**Verification and certification report form for
CDM project activities
(Version 03.0)**

Title and UNFCCC reference number of the project activity	Landfill Gas Recovery and Flaring Project in El Verde Landfill Leon UNFCCC ID: 3378
Scale of the project activity	<input checked="" type="checkbox"/> Large-scale <input type="checkbox"/> Small-scale
Version number of the verification and certification report	1.0
Completion date of the verification and certification report	20/12/2019
Monitoring period number and duration of this monitoring period	6 th MP (1 st MP of the 2 nd CP) 27/10/2017 – 31/12/2018 (including both days)
Version number of the monitoring report to which this report applies	6.0
Crediting period of the project activity corresponding to this monitoring period	27/10/2017 – 26/10/2024 (including both days)
Project participants	Promotora Ambiental S.A.B. de C.V. First Climate AG
Host Party	Mexico
Applied methodologies and standardized baselines	ACM0001: Flaring or use of landfill gas, version 18

"Landfill Gas Recovery and Flaring Project in the El Verde Landfill, Leon"

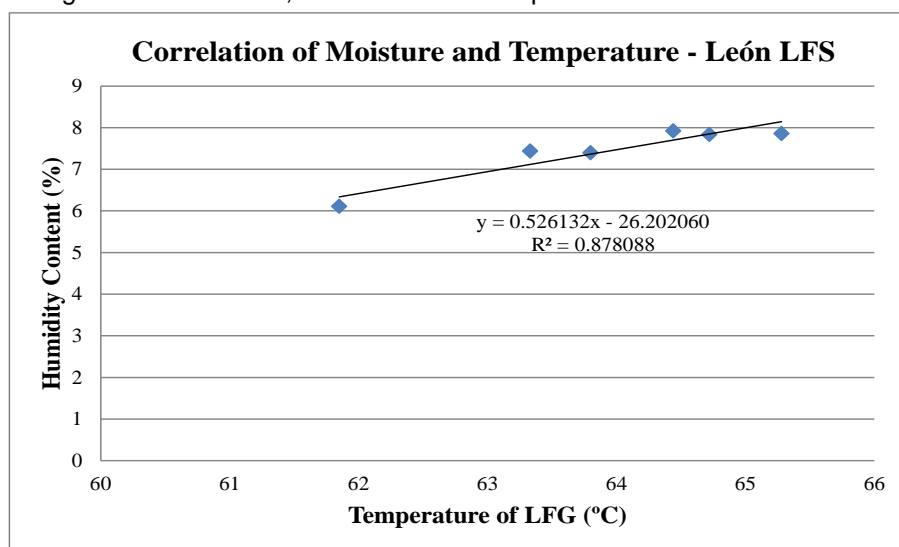
Project participant response				Date: 30/09/2019
<ol style="list-style-type: none"> 1) During the first crediting period, the CDM-PDD did not have any reference to the "Tool to determine the mass flow of a greenhouse gas in a gaseous stream" to correct the flow to dry basis when the temperature was greater than 60°C and there was not guidance to properly apply it. Moreover, considering that during the monitoring period no separate monitoring of temperature and pressure is necessary since the PP is using flowmeters that automatically express LFG volumes in normalized cubic meters, there is no measurement of the pressure of the gas to apply the Option 2 (Simplified calculation without measurement of the moisture content) of the "Tool to determine the mass flow of a GHG in a gaseous stream" version 3.0 Considering such situation, for the first submission of this monitoring period, rather than using the using equation (8) of the "Tool to determine the mass flow of a greenhouse gas in a gaseous stream" version 3.0, the PP hired the third party consultancy IECASA to measure the moisture content of the gas (vH₂O,t,db) as can be evidenced with the "Moisture Content Report_Leon_Feb-11". The experiment was conducted by artificially (i.e increasing the booster's suction) increasing the temperature of the gas above 60°C and measuring the moisture content of the gas to find a correlation between the temperature of the gas and its moisture content, as follows:

Temperature LFG (°C)	vH ₂ O,t,db (%)
63.33	7.429
61.85	6.103
64.44	7.916
64.72	7.828
63.80	7.389
65.28	7.852

- 1) In line with the clarification provided by the PP, during the first crediting period, the CDM-PDD did not have any reference to the "Tool to determine the mass flow of a greenhouse gas in a gaseous stream" to correct the flow to dry basis when the temperature $> 60^\circ C$, and the PP provided an alternative method in line with thermodynamics principles and such situation was not updated in renewal of the crediting period. The PP decision to conservatively disregard all flows values $T > 60^\circ C$ (wet basis) is correct and in line with the registered PDD choices and also the re-calculated ER value is conservative; this is verified in columns D and E of spreadsheet /error/ in xls file Raw_Data_EI_Verde_6MP_v5.
